Horace Planning & Zoning Commission Meeting Agenda

**CITY OF HORACE:
PLANNING AND ZONING
COMMISSION
STAFF REPORT**

Entitlements Requested:	Subdivision	Zone Change	Design Review	Conditional Use	Variance	Lot Spilt	Other
Title:	Deer Creek Estates 3 rd Addition		Application Number:		CD-2023-28		
Date:	11/28/2023		Staff Contact:		Jace Hellman		
Owner(s)/Applicant:	HS Investments LLC		Applicant Contact:		Matthew@brookestoneproperty.com		
Representative:	Andrew Thill – Lowry Engineering		Representative Contact:		athill@lowryeng.com

**EAGLE RIDGE
DEVELOPMENT**
**PSV COMMERCIAL
BUILDING**
HORACE, NORTH DAKOTA

GRADING PLAN

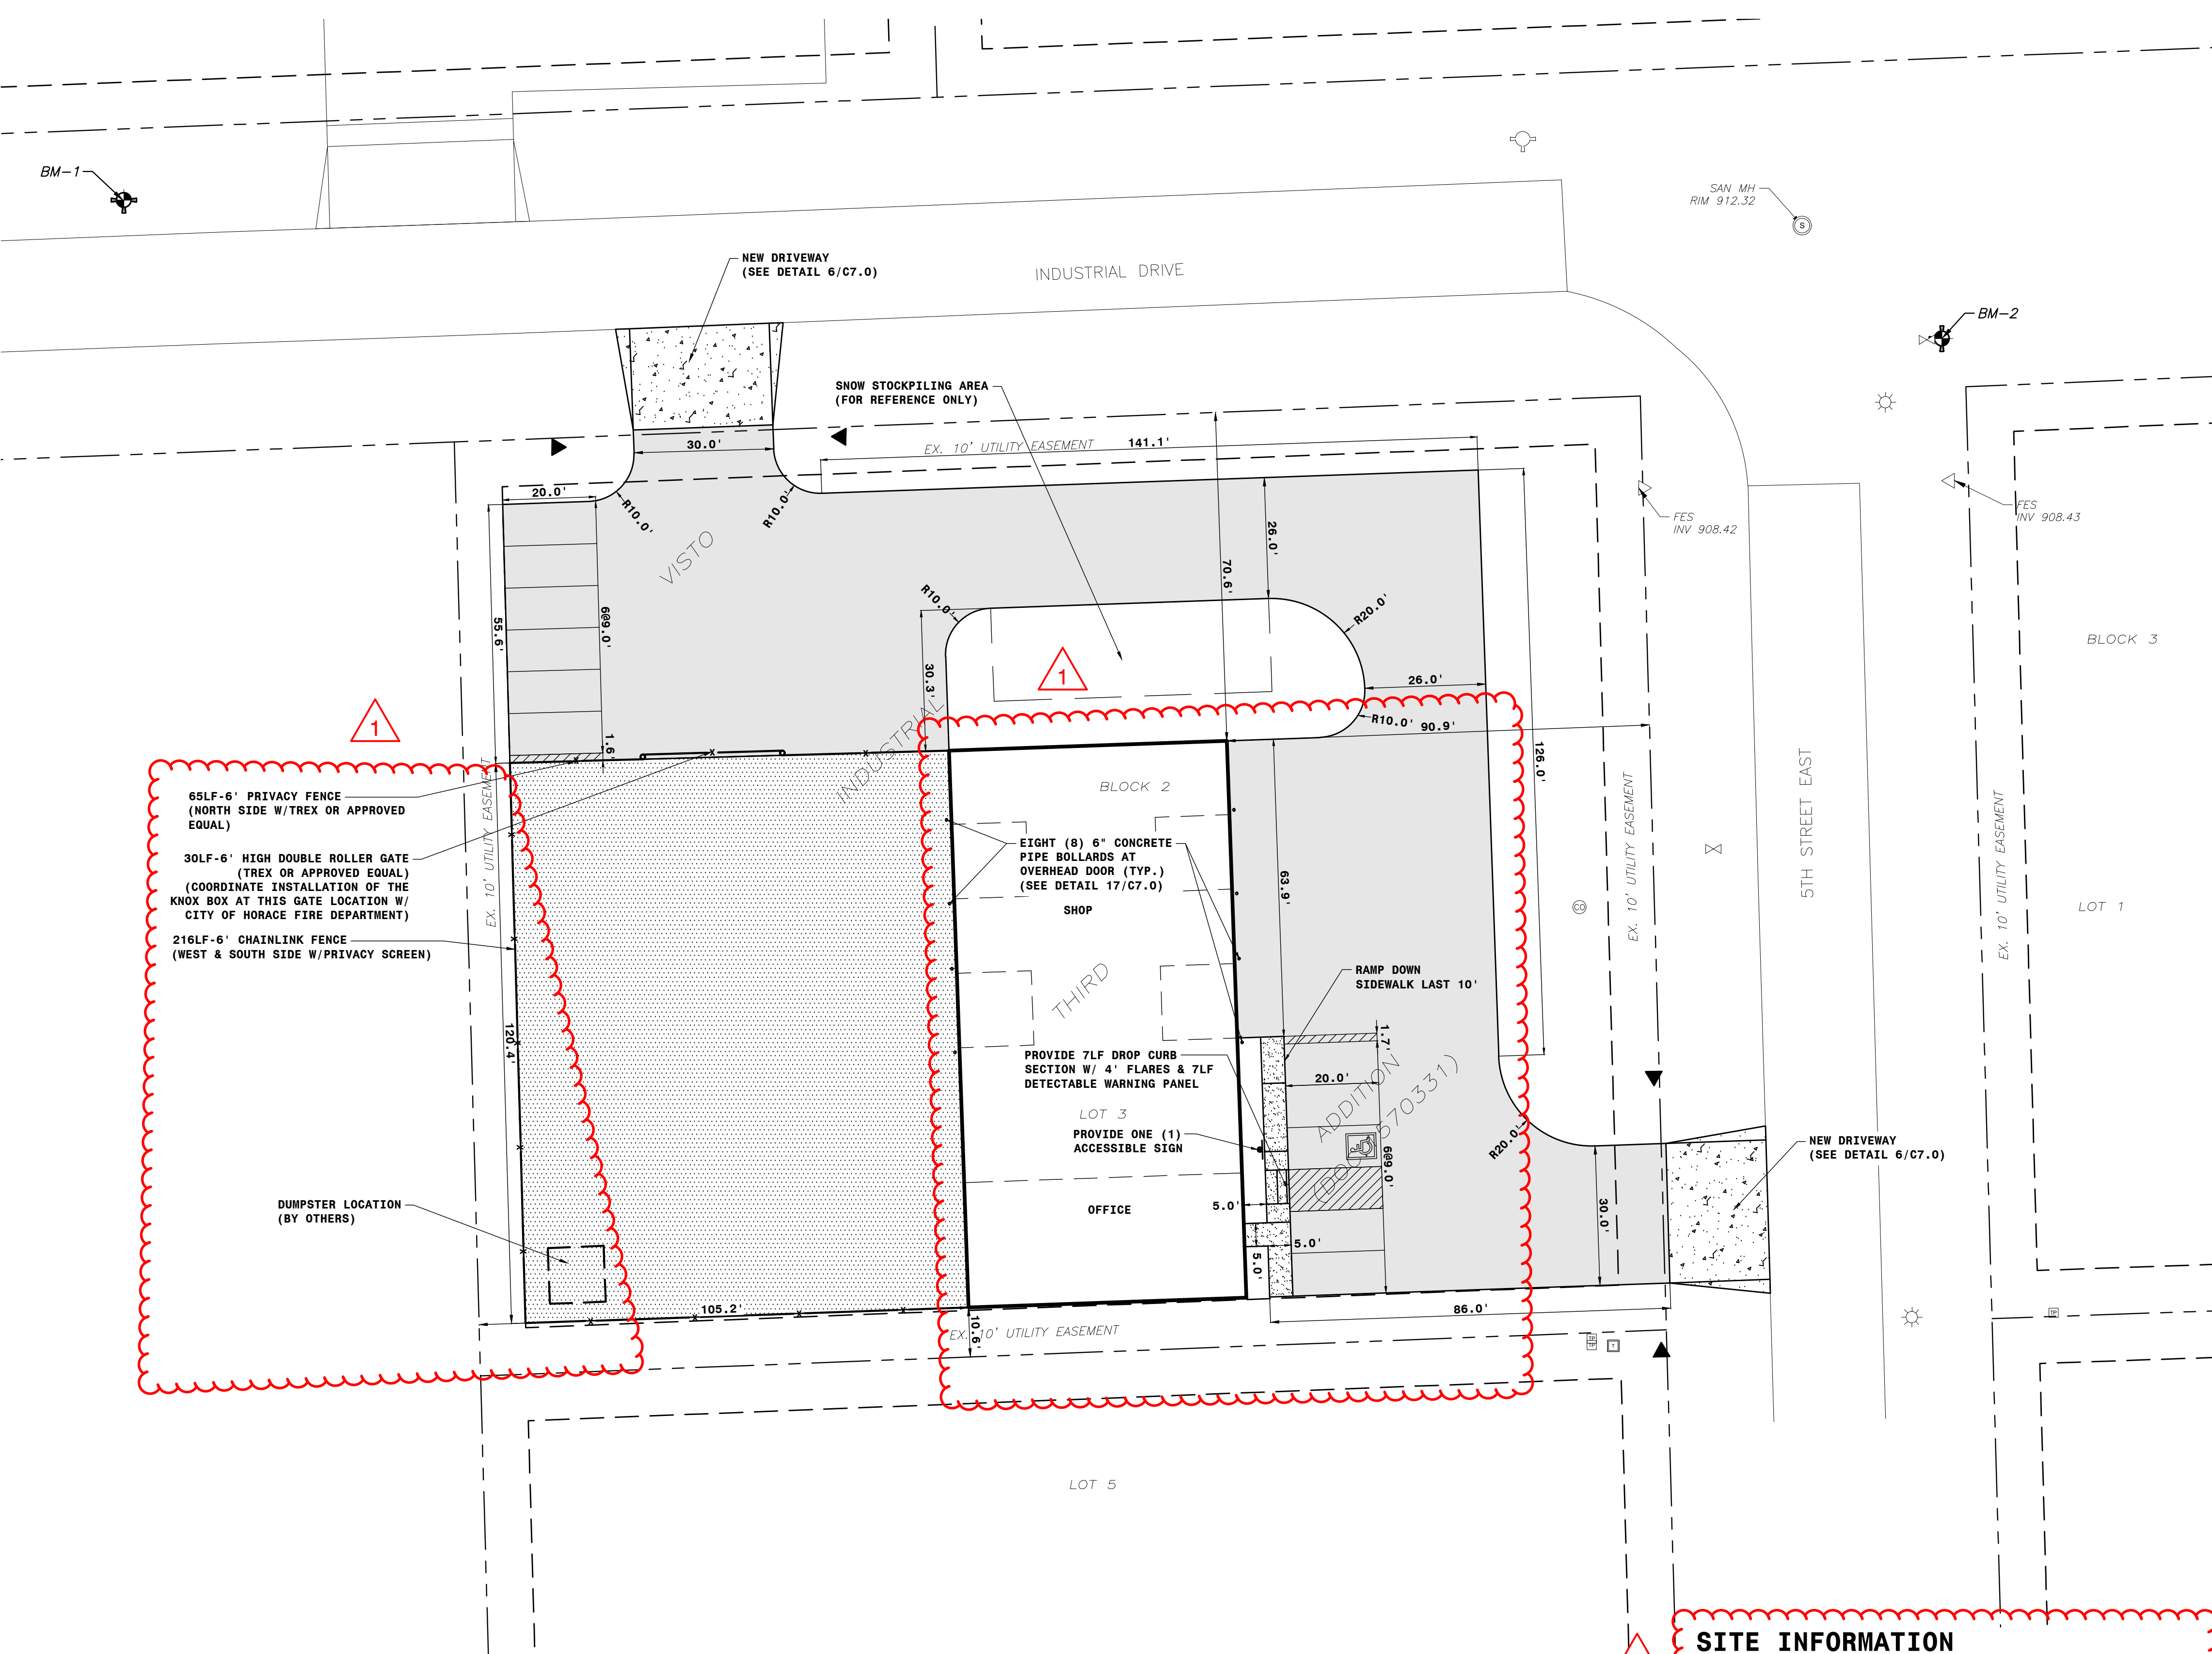
- **Sheet C2:** Please relocate the planting units within the open ditch. Although required by City Ordinance, the Visto’s Development has proven unable to accommodate the boulevard trees. Trees should be relocated to other areas on the property. *see attached civil response*

16 CHAIN LINK FENCE DETAIL W/ PRIVACY SCREEN
NOT-TO-SCALE

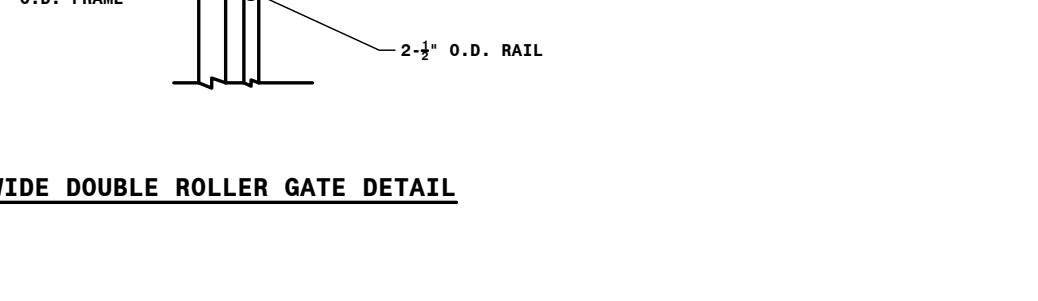
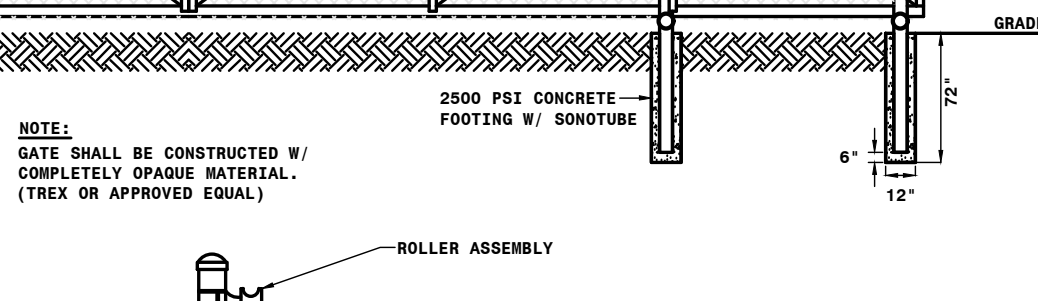
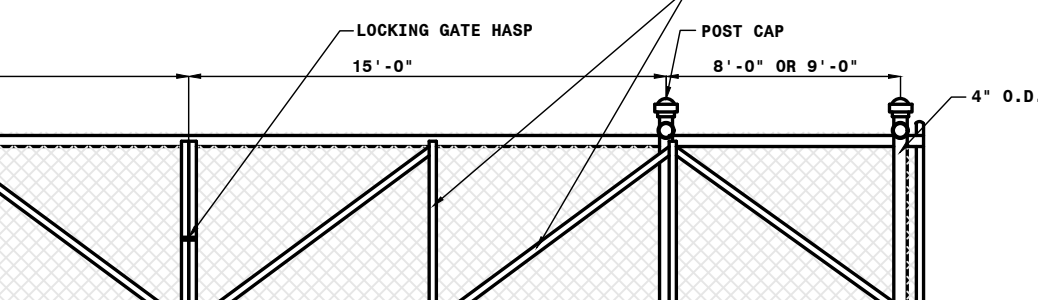
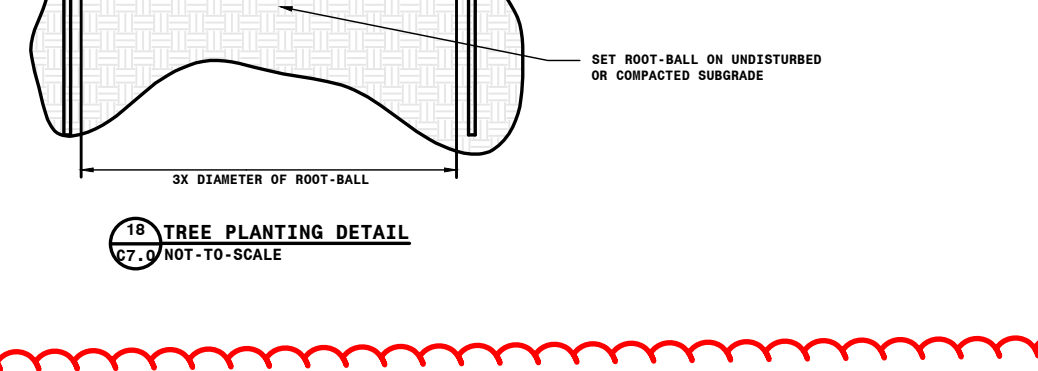
- **Sheet C-5:** Per Horace City Code 17.8.12 (6) (c) (ii) requires all outdoor storage to not be visible from the main public street frontage. Chain link with privacy screen is not listed as a permitted material. Please provide opaque fencing or architectural screen walls.

C1
A200 WEST ELEVATION
1/8" = 1'-0"

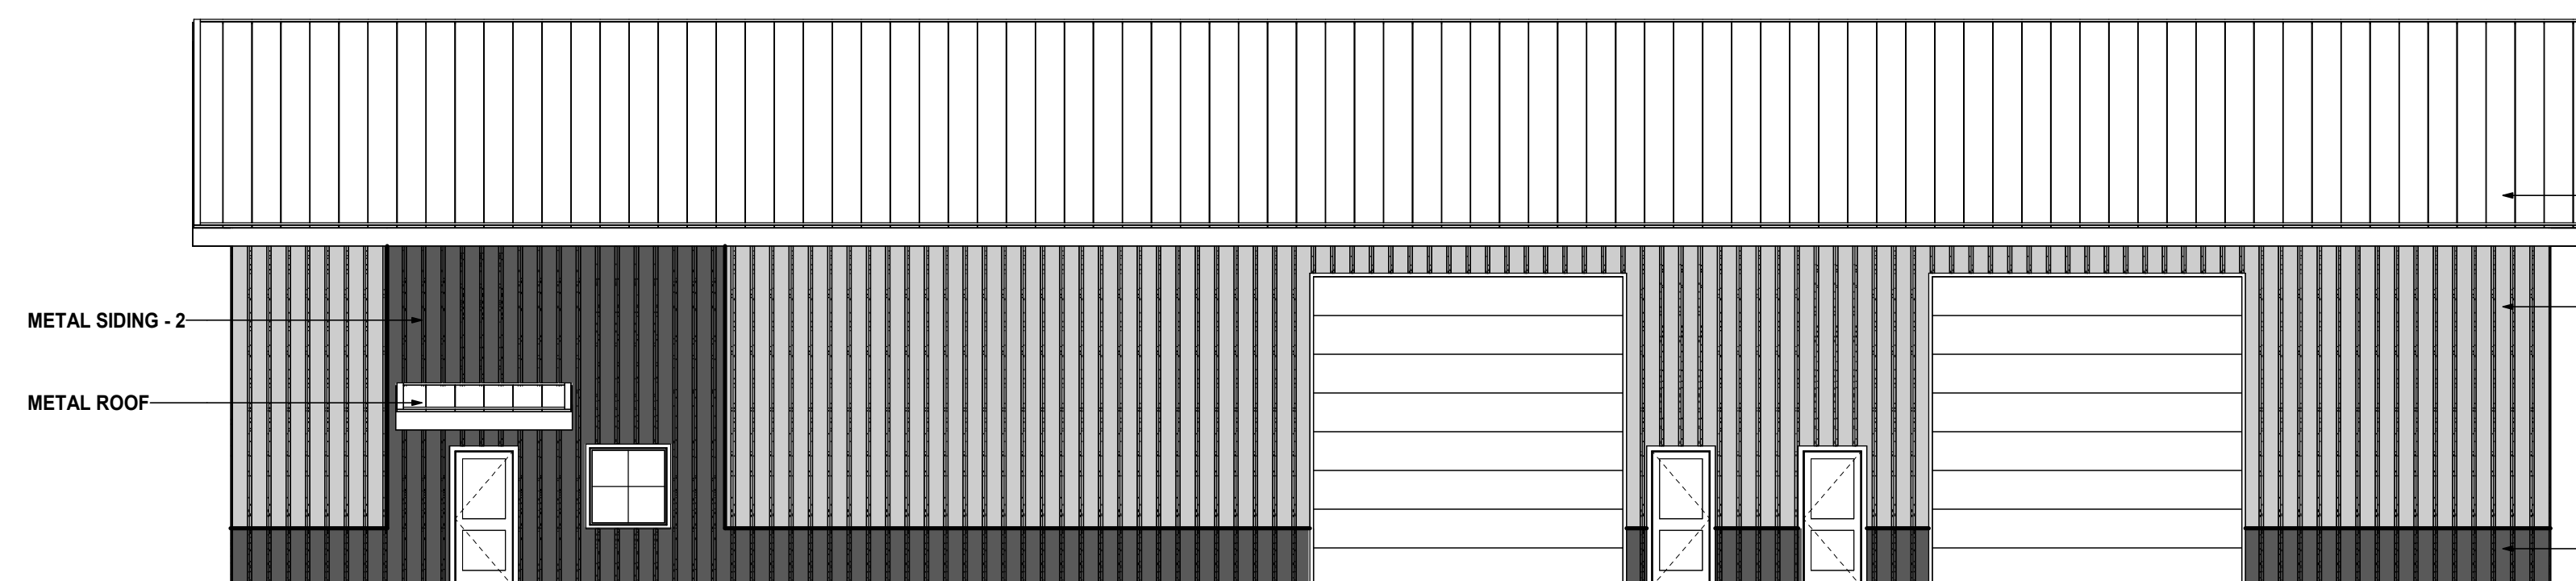
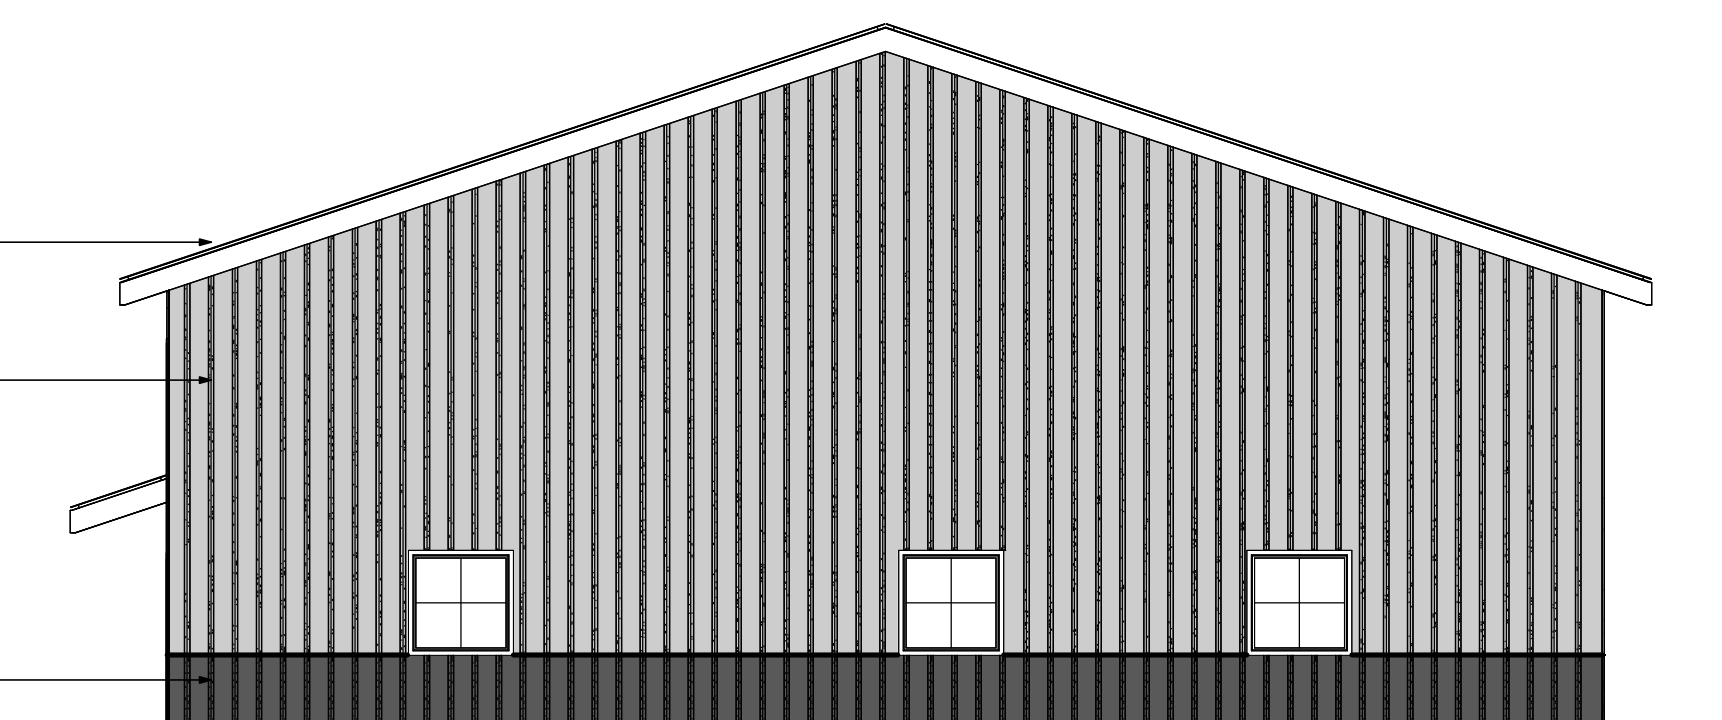
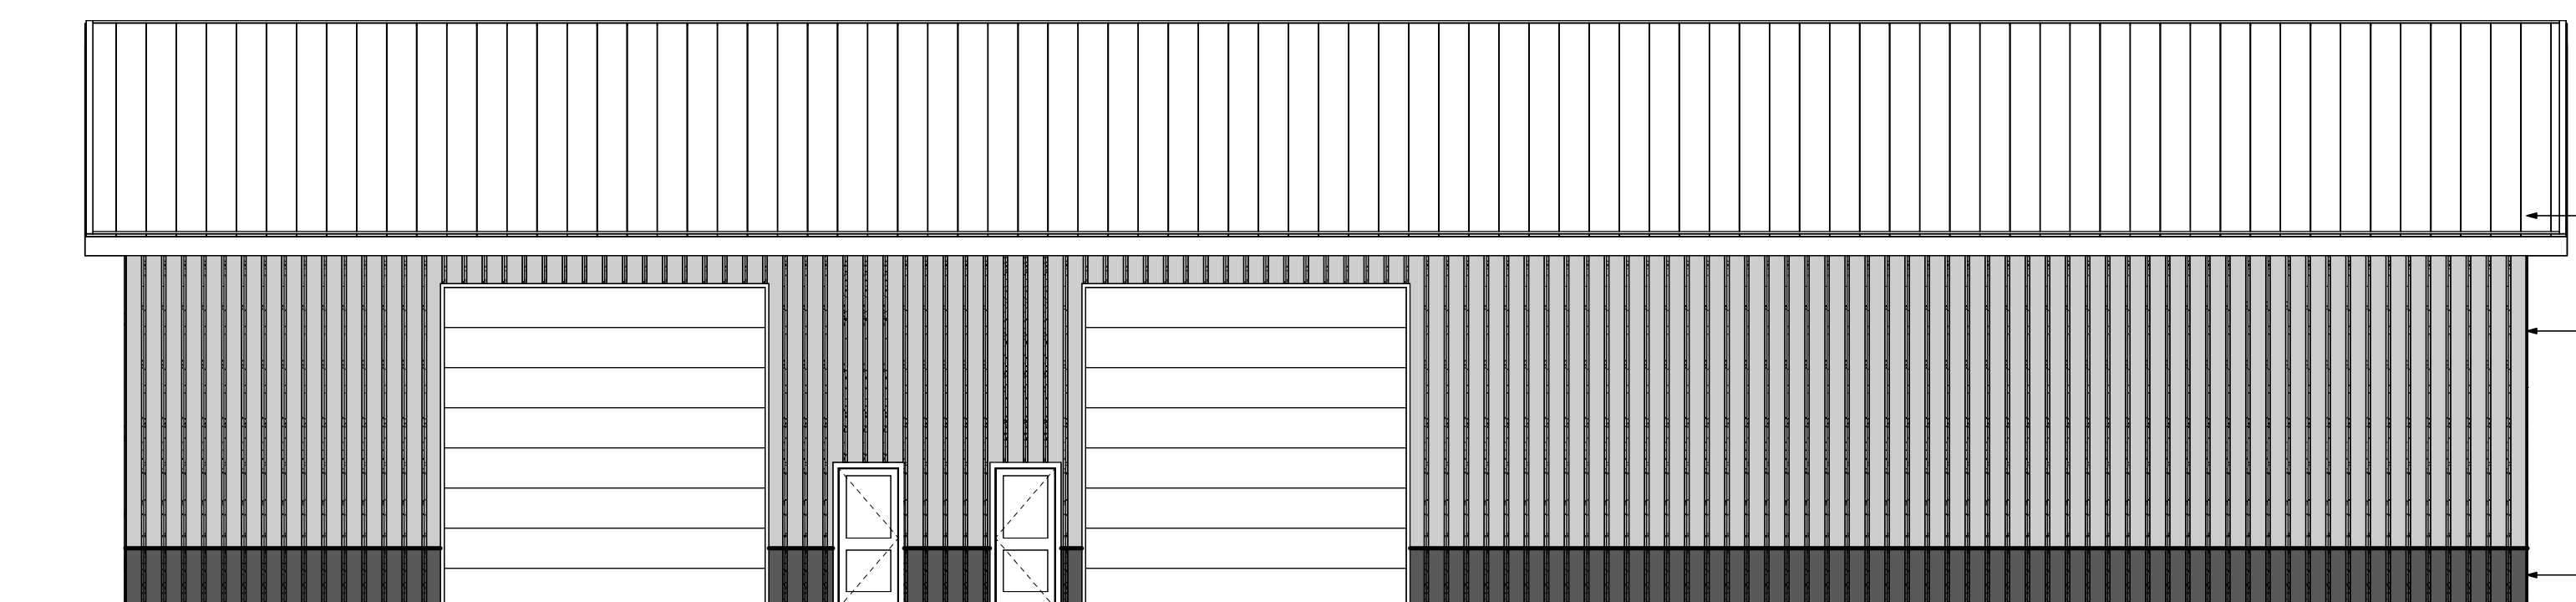
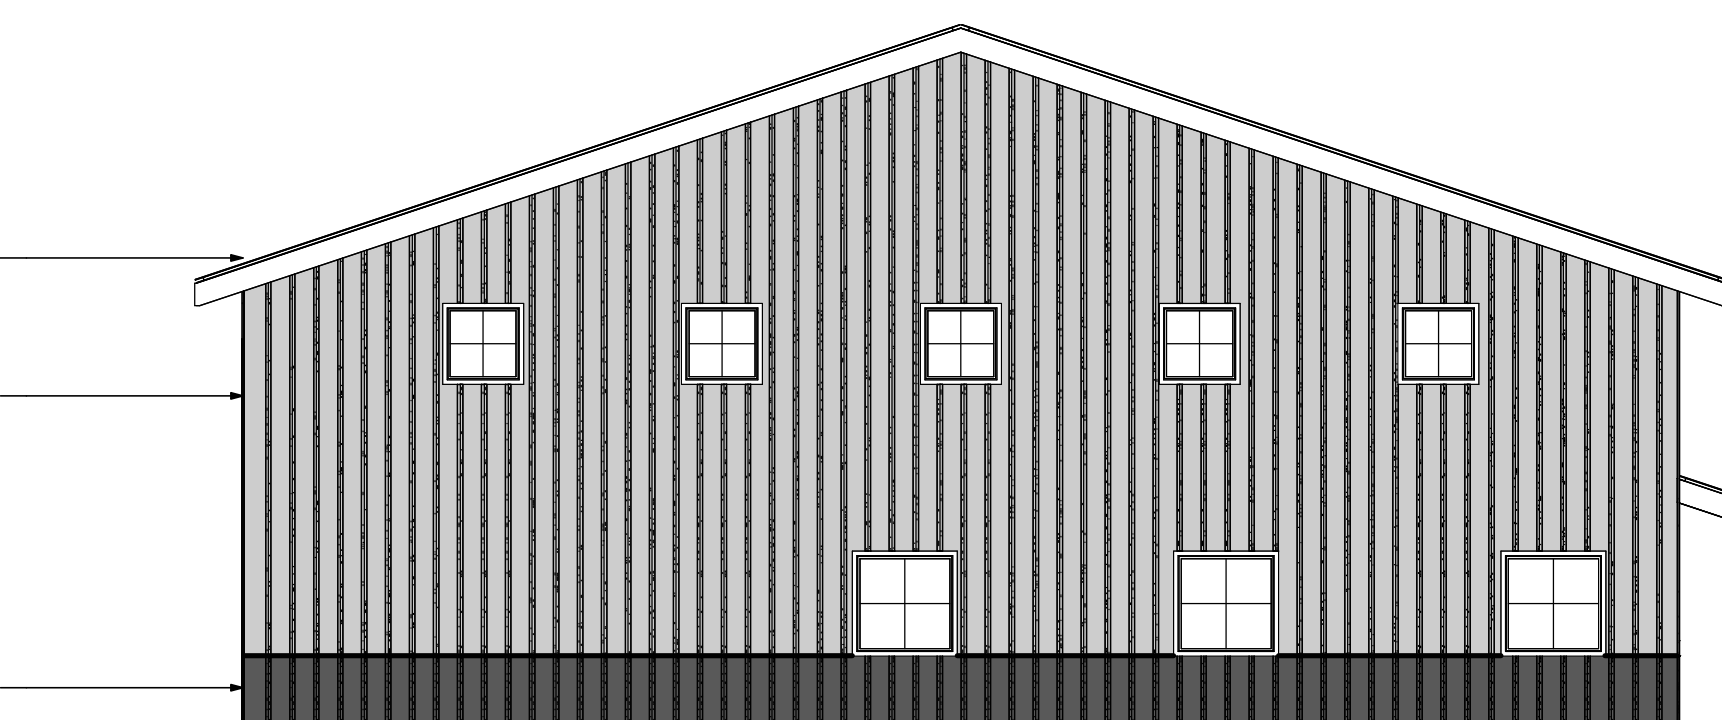
- **Sheet A200:** Please provide color descriptions of roof, siding, and veneer materials. *see attached architectural drawings*
- **Sheet A-4:** Please provide viewpoint directions for elevations. *see attached architectural drawings*
